Delmore Fast-Track

04/05/2026 – Auckland Council Response

Auckland Transport

Specialist Response Template – Fast-track Approvals Act 2024 Substantive Application

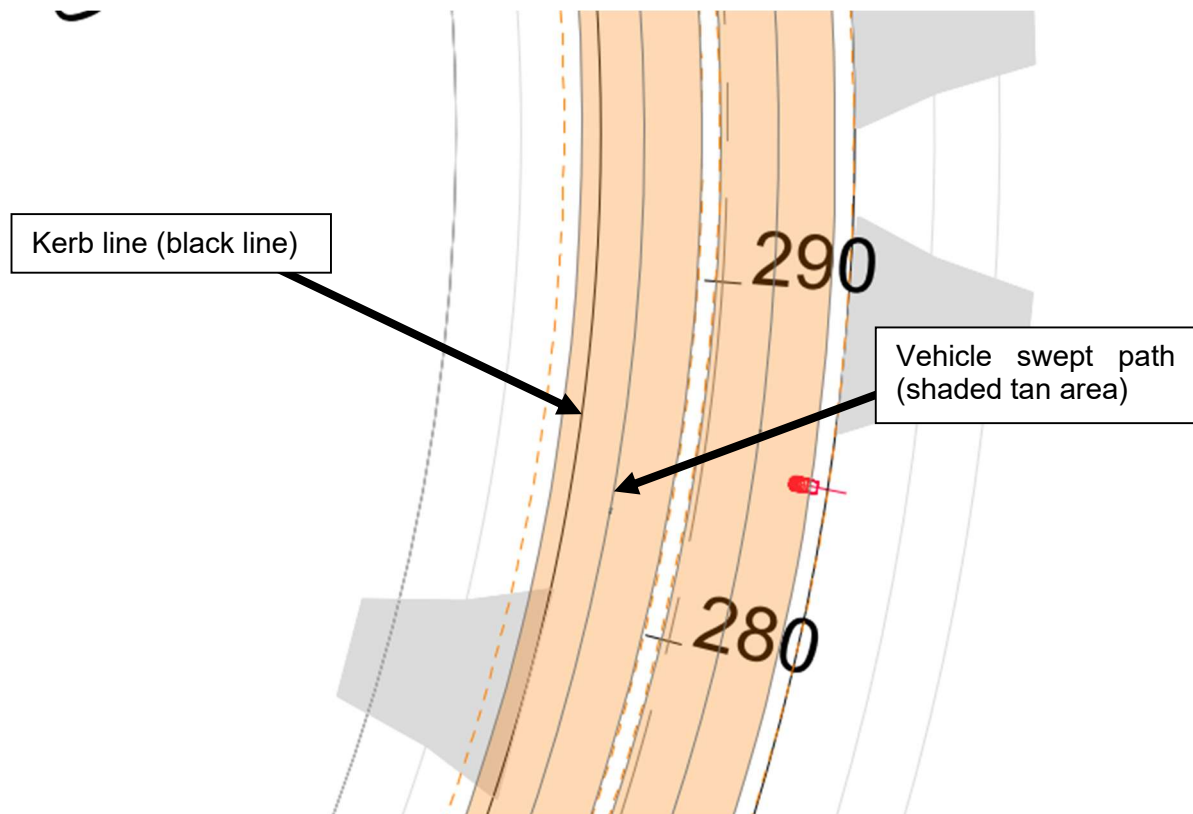
77. Vehicles track over kerb lines on the following Commute Tracking Drawings in relation to the following locations.
 - Drawing 26A - Intersection of Roads 22/26.

- Drawing 7D - JOAL9/Road 1.
78. No tracking drawing has been provided for the JOAL11/Road 1, JOAL11/Road 1, or JOAL 37/Road 4 vehicle crossings.
79. The applicant has proposed Condition 113 which reads;
"113. Sufficient carriageway space is to be provided to ensure vehicle tracking in compliance with the Auckland Code of Practice for Land Development and Subdivision Chapter 3 Transport without the footpath or berm widths going below the minimums in the Code."

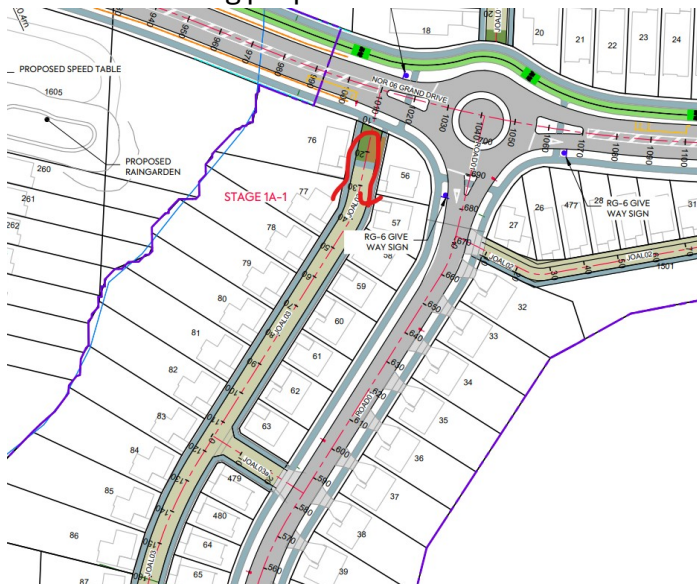
I found some of TE concerns were not addressed in the new drawings, please see the comments below:

1. Speed table placement (previously raised concern):

3. Missing legend of brown colour area:

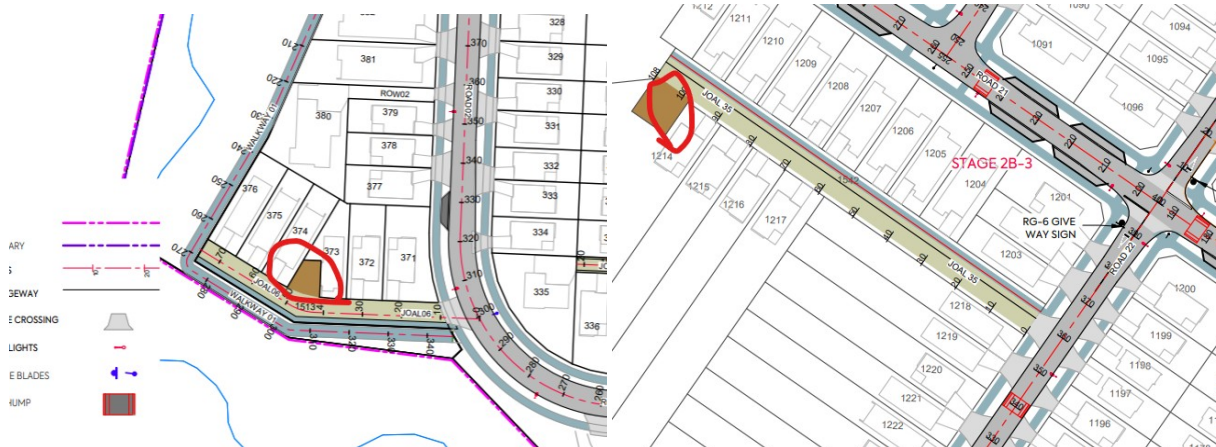
It is unclear whether the new brown-coloured areas are intended to represent? please confirm.

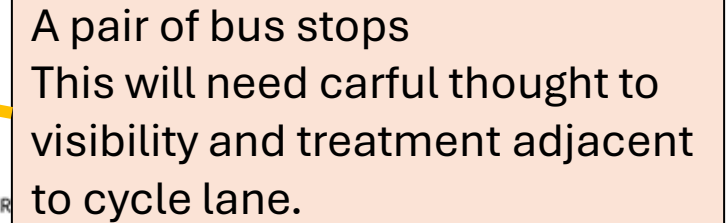
Location	Approx Chainage	Intervention	Notes
Intersection of NOR 6/ Road 5 / Road 6	510	Make roundabout big enough for buses to U-turn using NOR 6	
NOR 6	About 580	A pair of bus stops	Visibility checks Will need pedestrian refuge Cycle lanes – safe for bus passengers
Intersection of NOR 6 (1040) / Road 1	1040	Make roundabout big enough for buses to U-turn using NOR 6	
NOR 6	1100	A pair of bus stops near roundabout - ideally downstream of Roundabout 990 & 1100	Bike lane
Road 1	about 350 southbound about 380 northbound	Design for a pair of bus stops. (not build)	Visibility checks Will need pedestrian refuge Cycle lanes – safe for bus passengers
Russell Road / Road 1 (000)		Ensure that the future intersection can be made suitable for buses. Road 1 to Russell Rd and vice-a-versa

- Roundabout needs to be designed to enable buses to U-turn in the interim until roads are connected through to Upper Orewa Rd

Stage 1

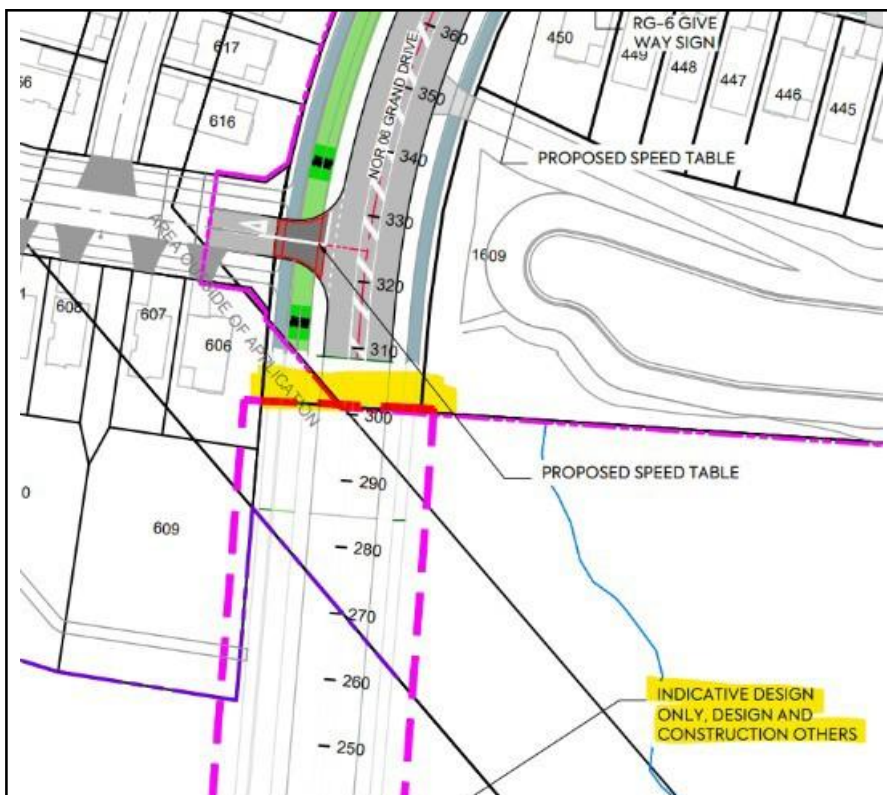
- Sheet 1 details some road formation on part of paper road for NOR 6 road. We had noted to Delmore previously that formation works will required CAR.
- Sheet 2 details Joal13 being formed up to boundary of paper road.

Nothing in Stage 1 details any road stopping requirement.

Stage 2 - Sheet 1

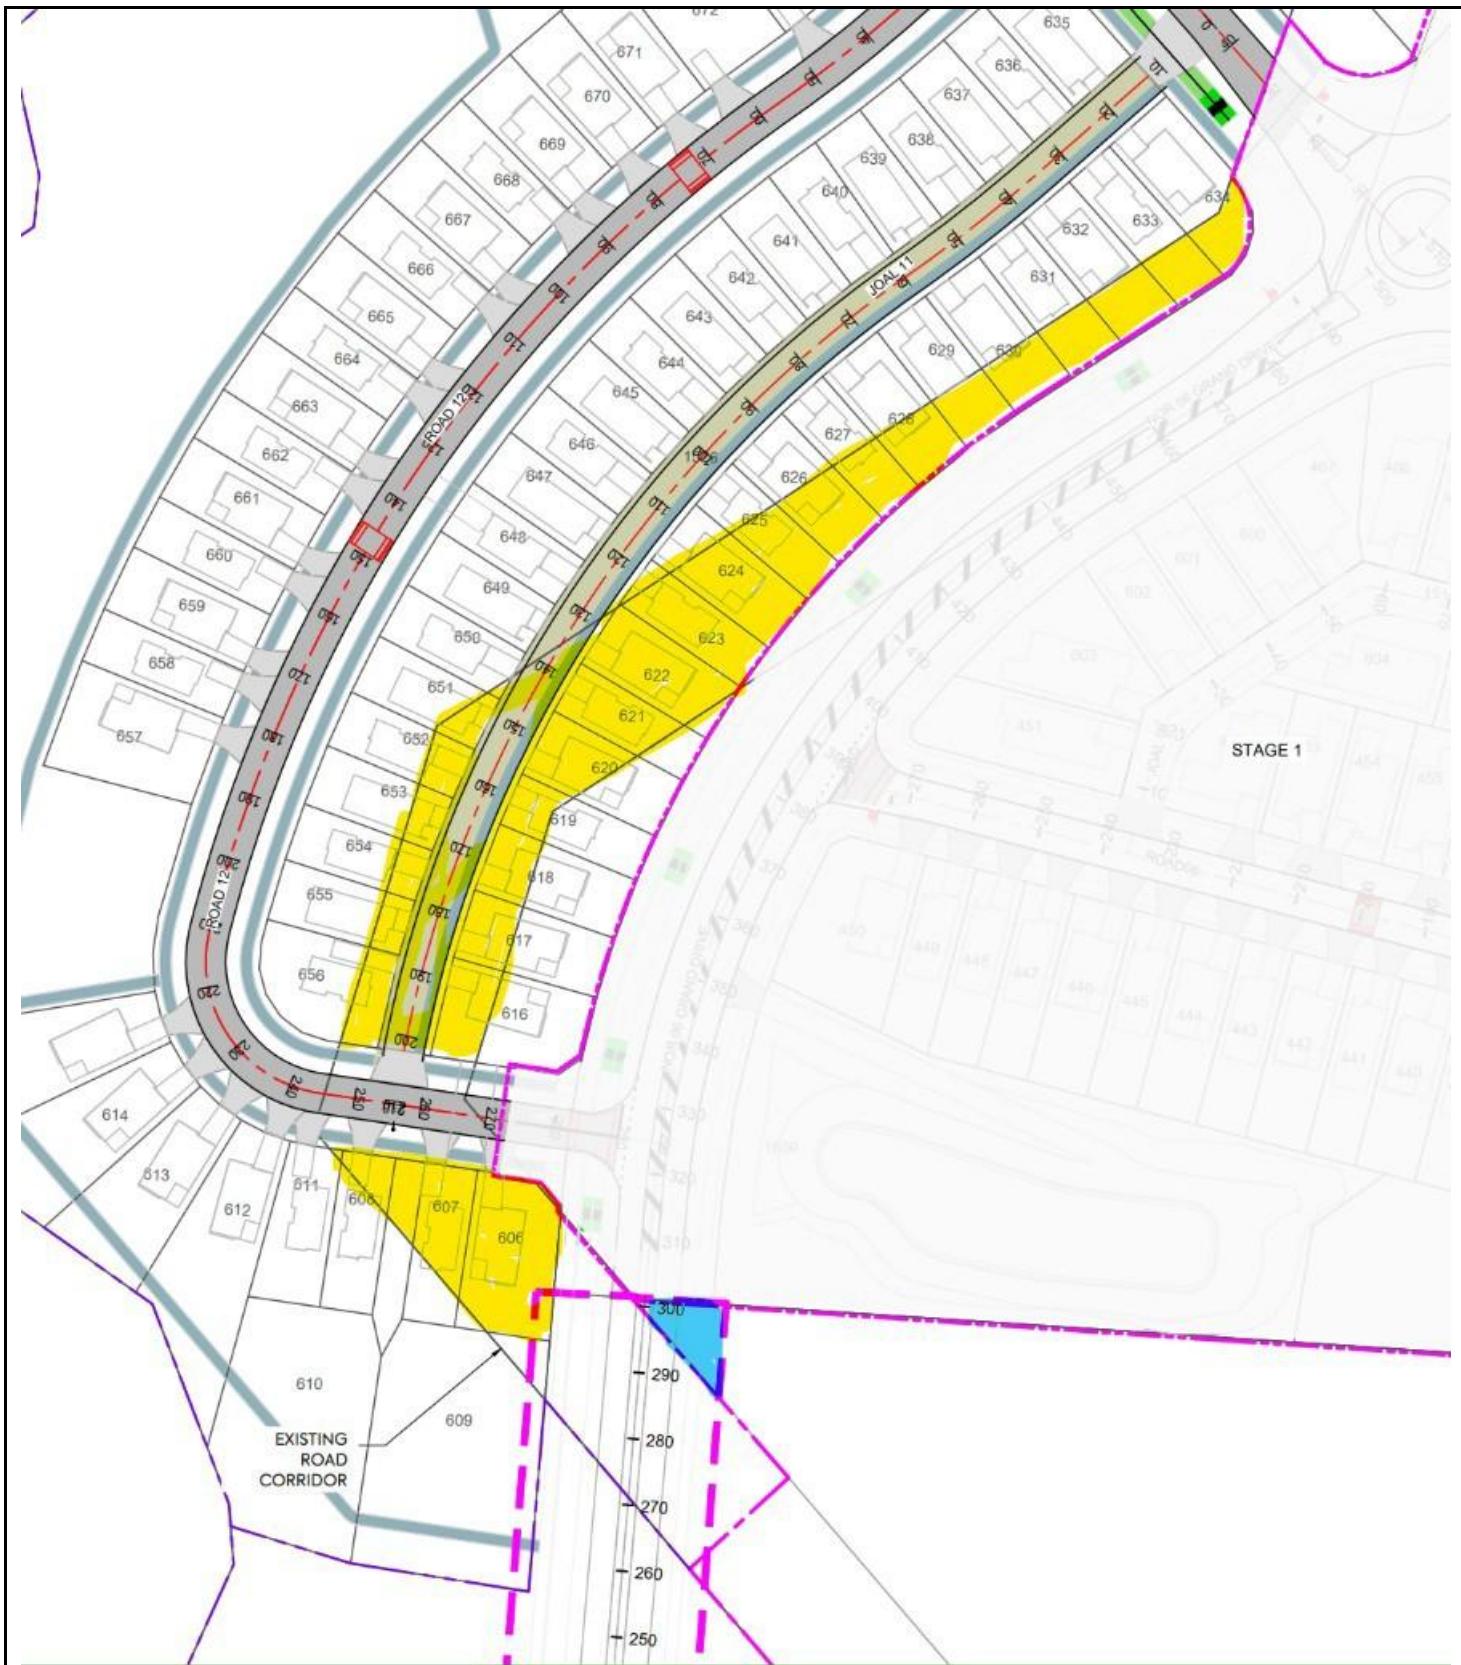
- Sheet 1 – the yellow highlighted area details subdivision lots on the paper road. From our last discussion with Delmore we understood they were putting in a stage 1A or 2A?
To deal with road stopping requirements once the NOR 6 is vested then stopping of the yellow section of paper road to progress

The highlighted triangle area below was raised previously to Delmore. Prior plans noted this was section of land in NOR was to be acquired by others?

Without the highlighted triangle area as road, it creates a pinch point in the existing paper road and new NOR. This is likely to impact the proposed road stopping for the yellow sections if a full width road is not provided/remaining.

Stage 2 – sheet 2

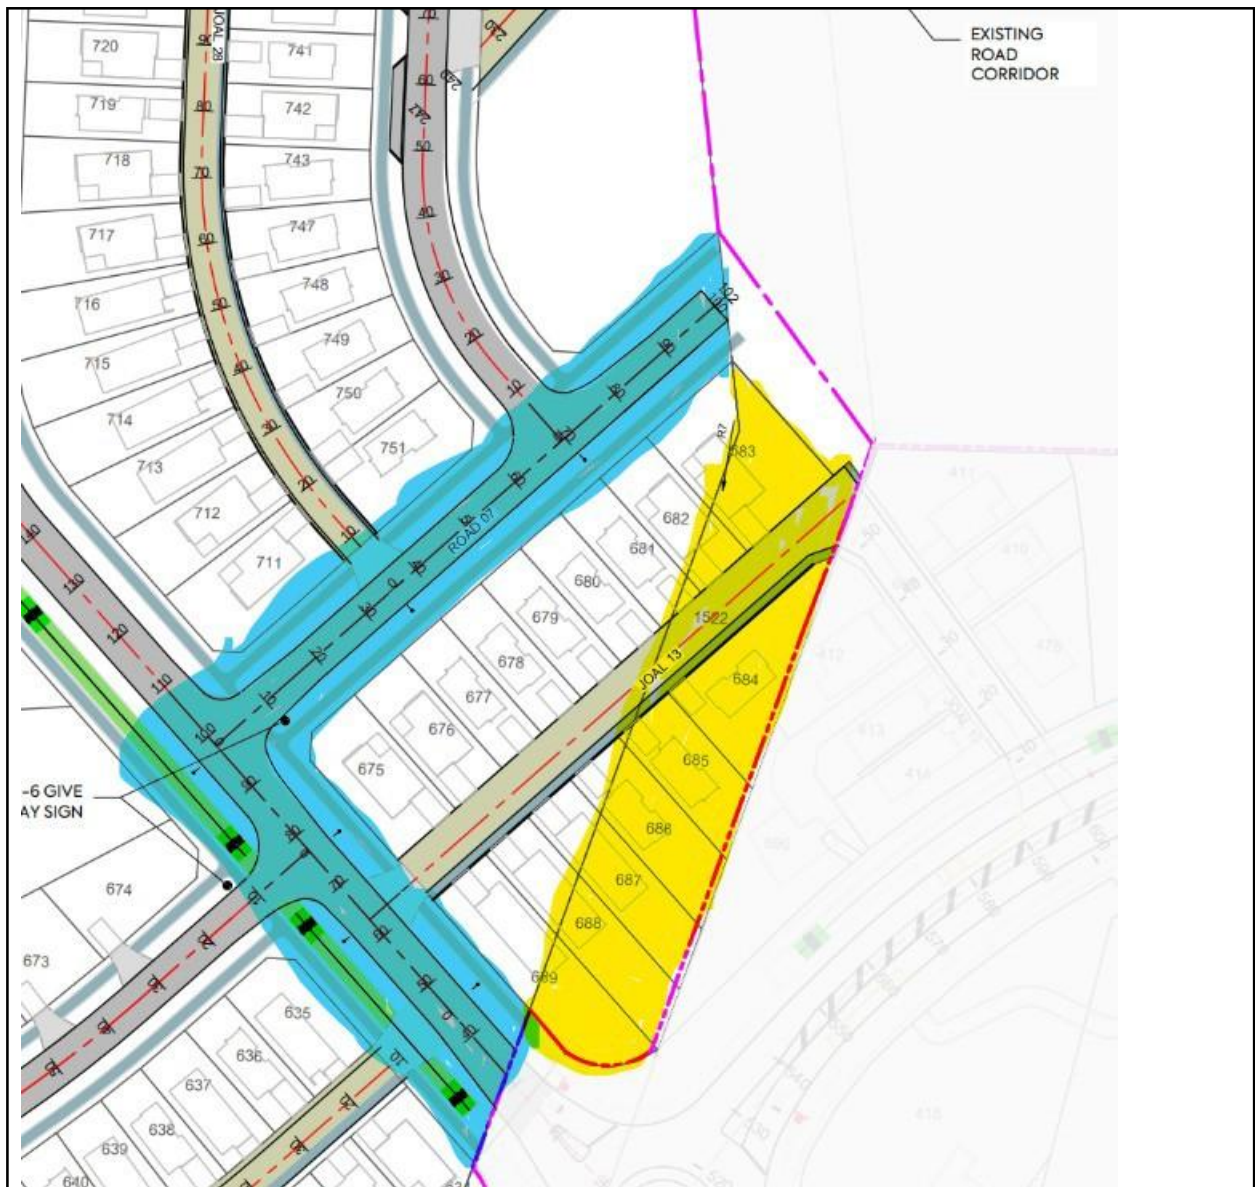
- Sheet 2 - the yellow highlighted area details subdivision lots on the paper road. From our last discussion with Delmore we understood they were putting in a stage 1A or 2A?
- The blue highlighted section of new road needs to be vested prior to the yellow section being stopped.
